**Version: October 15, 2024**

**Oregon Supplement to the  
Manual on Uniform  
Traffic Control Devices  
for Streets and Highways  
11th Edition**

This is a compilation of draft proposals for the Oregon Supplement to the MUTCD 11<sup>th</sup> Edition as of the version date above. This is not official Oregon Supplement content. This is provided for information only. ODOT might edit final proposed language to fit with the scope and style of the Oregon Supplement to the MUTCD.

**Figure 8C-1(OR). Example of Placement of Warning Signs and Pavement Markings at Grade Crossings**

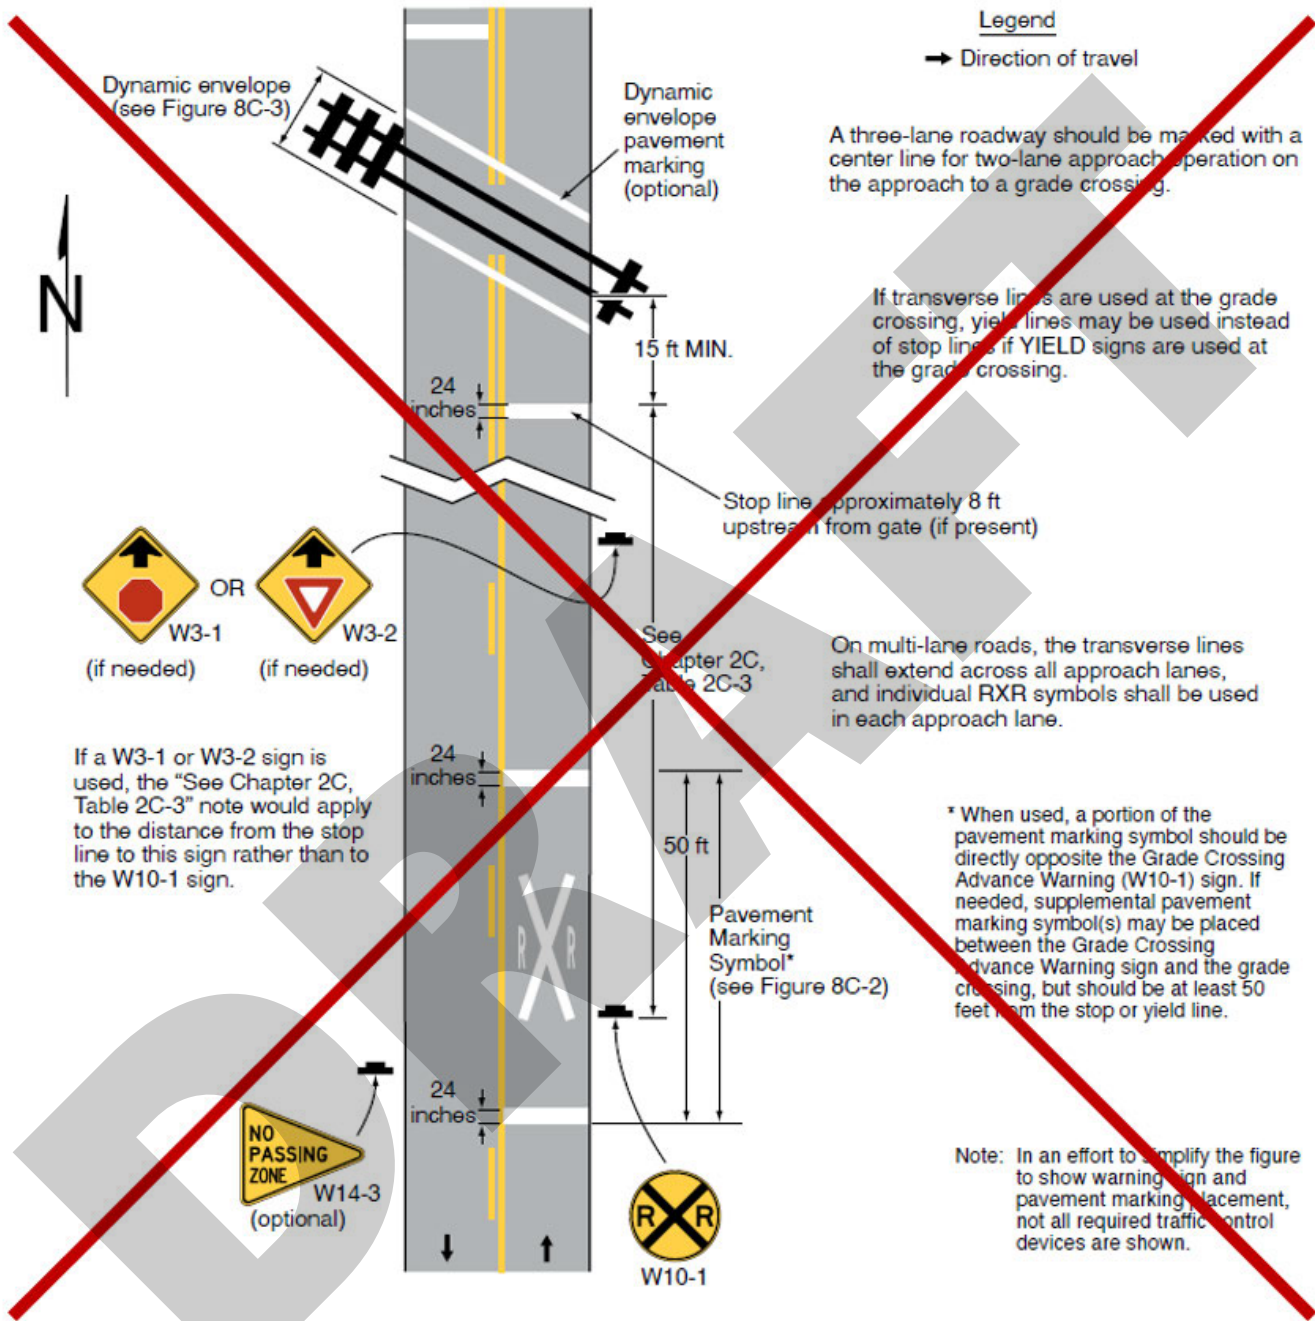
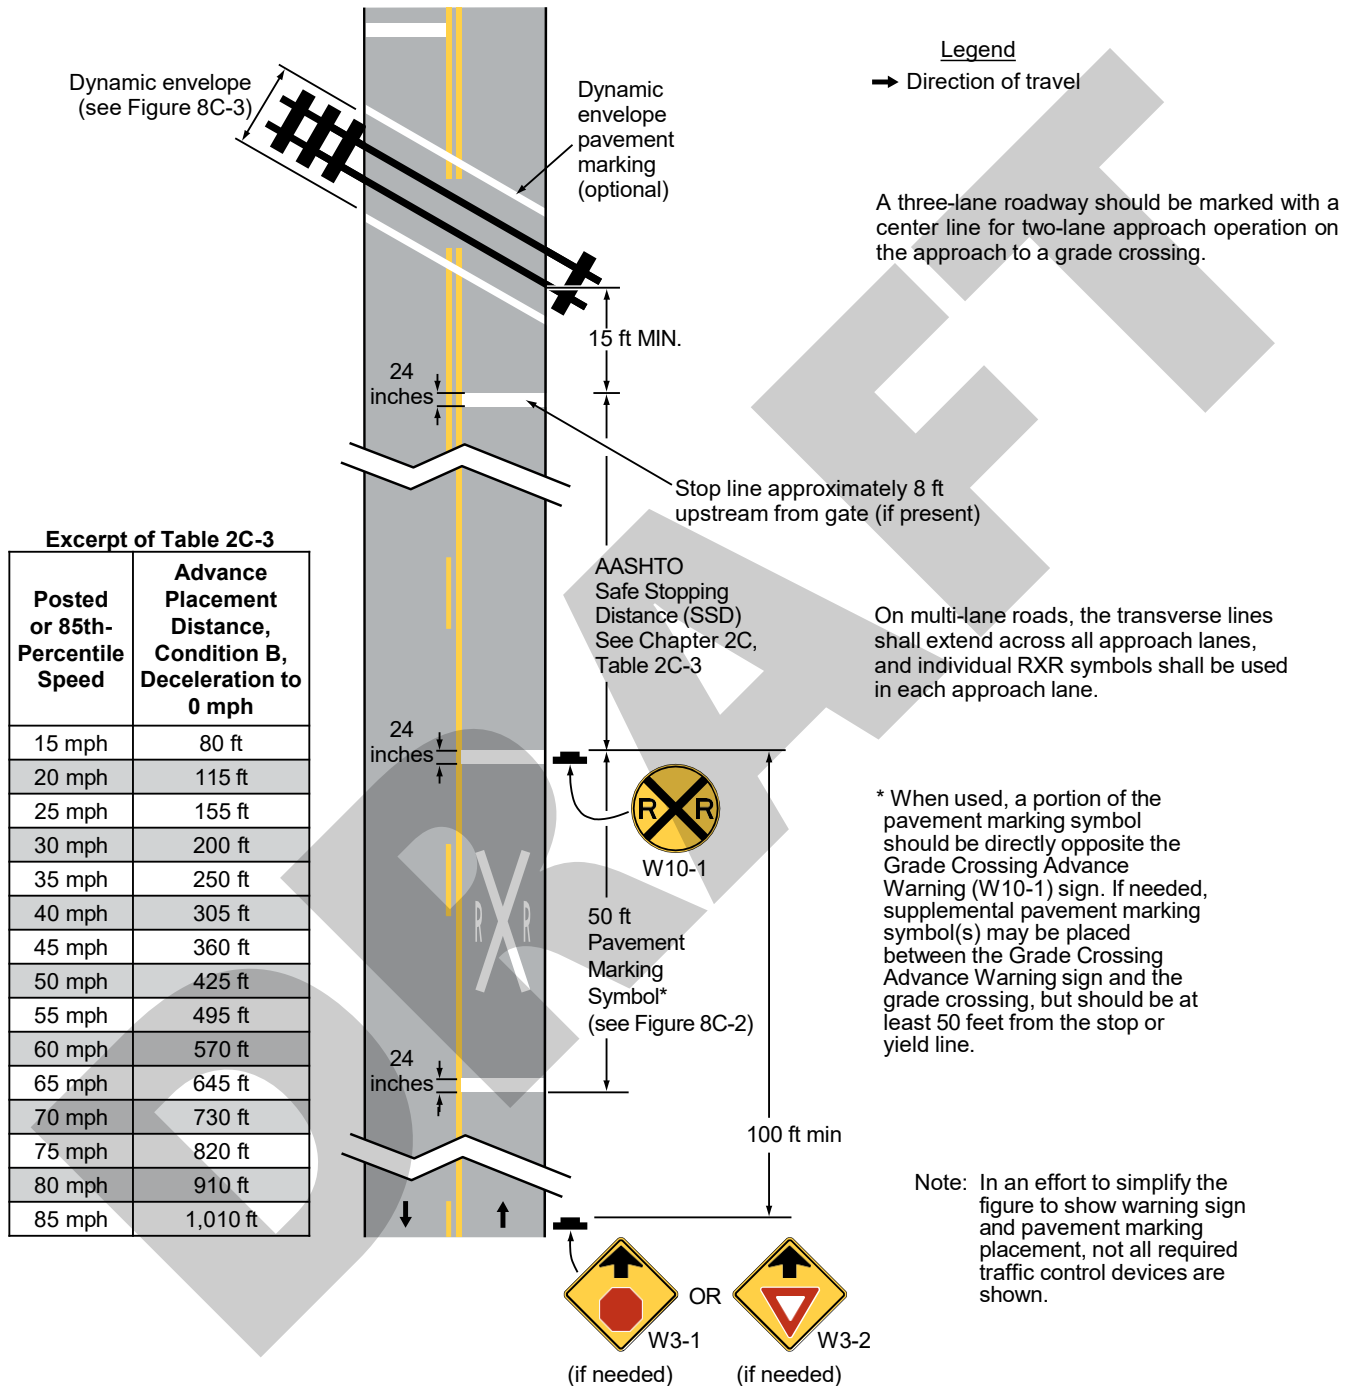
20 The MUTCD provides more flexibility in the placement of the RxR pavement marking symbol than  
21 Figure 8B-06(OR) which was deemed acceptable for future installations.

23 Again, no documentation was found for the placement of the W3-1 or W3-2 signs as shown in Figure  
24 8B-06(OR). There are approximately 805 existing assets that would require swapping the W3-1 or W3-2  
25 sign with the W10-1 sign. This then requires moving the existing railroad pavement marking symbol to  
26 the new W10-1 sign location and extending the centerline no-pass striping as well. This work is  
27 estimated to be approximately \$4,500 per asset, for a total of \$3.6 million to address all assets. While  
28 national uniformity is important, in this case it has minimal benefit as there is no data to show  
29 swapping the sign location results in an improvement and drivers would likely not even notice or  
30 remember a difference in the order of these signs. The cost to make these changes at the end of service  
31 life is significant given the current budget issues of public agencies. The benefit cost ratio is too low to

26 **Figure 3: Proposed Oregon Supplement layout, intersection stop line is the marked crosswalk**

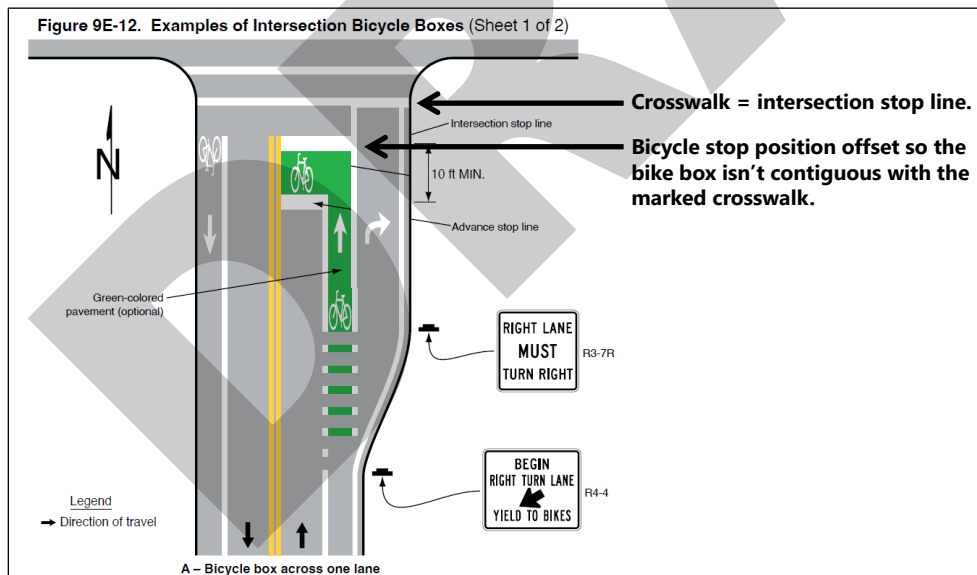
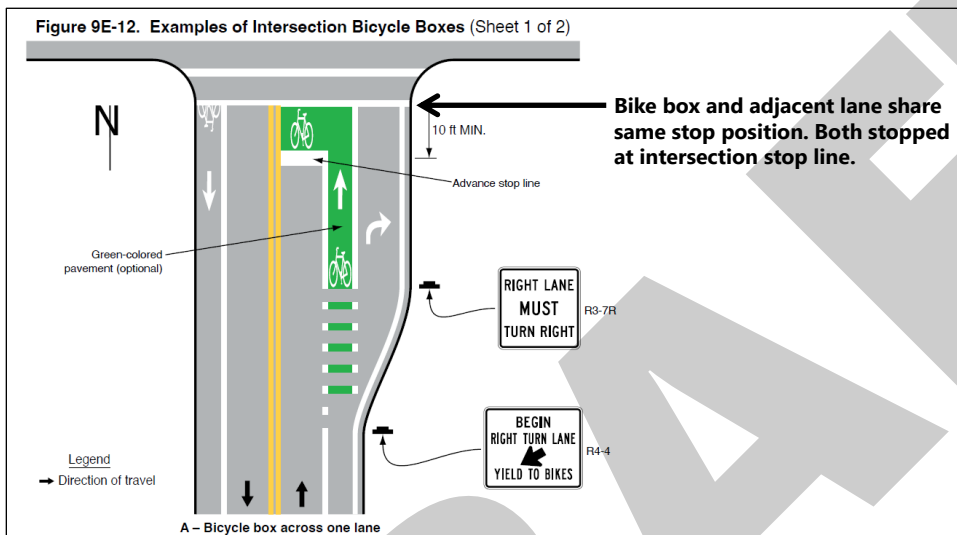
2 Section 9E.12 Paragraph 05 says a bicycle box should not be contiguous with a crosswalk, and a stop  
3 line on the downstream end of the bicycle box should be used to mark the location where bicycles are  
4 required to stop. However, Oregon has a long-standing practice (through Part 3 Oregon Supplement to  
5 the MUTCD) of using the marked crosswalk as the intersection's stop line.

11  
12 However, Oregon has a long-standing practice (through Part 3 Oregon Supplement to the MUTCD, see  
13 Proposal No. 11302) of using the marked crosswalk as the intersection's stop line. If the marked  
14 crosswalk is the intersection's stop line, but the bike box should not be contiguous with the crosswalk  
15 (as recommended in Section 9E.12 Paragraph 05), then the stop line for bicycles should be further back  
16 than the intersection stop line, shown in Figure 2.

19 If the marked crosswalk is the intersection’s stop line, then the Oregon Supplement should allow bike  
20 boxes to be contiguous with the marked crosswalk so the bike box and adjacent lane stop positions can  
21 share the same stop position – the intersection stop line – shown in Figure 3. This is how road  
22 authorities have installed bicycle boxes in Oregon to date. Figure 4 shows an example. This is also  
23 supported by the support statement in 9E.02 Paragraph 17: “Staggering stop lines (see Section 3B.19) so  
24 that general-purpose lanes stop further in advance from the intersection than the bicycle lane can  
25 improve the visibility of bicyclists for drivers of turning vehicles (see Drawing D in Figure 9E-7).”

**Figure 9E-14(OR). Optional Pavement Markings for a Shared-Use Path with Mode Separation**

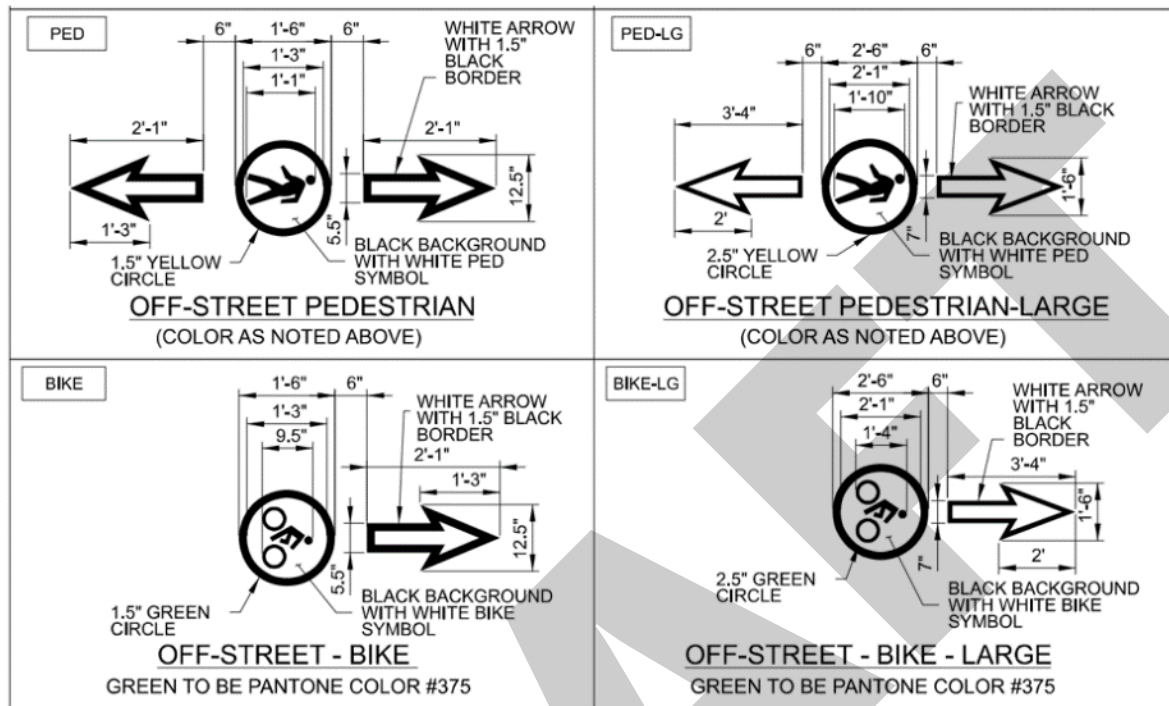
101 07 *If parallel bicycle and pedestrian crossing markings are used where a shared-use path crosses a*  
102 *roadway, crossing areas for bicycles should use green-colored pavement if the shared-use path crossing has*  
103 *a high volume of either mode.*
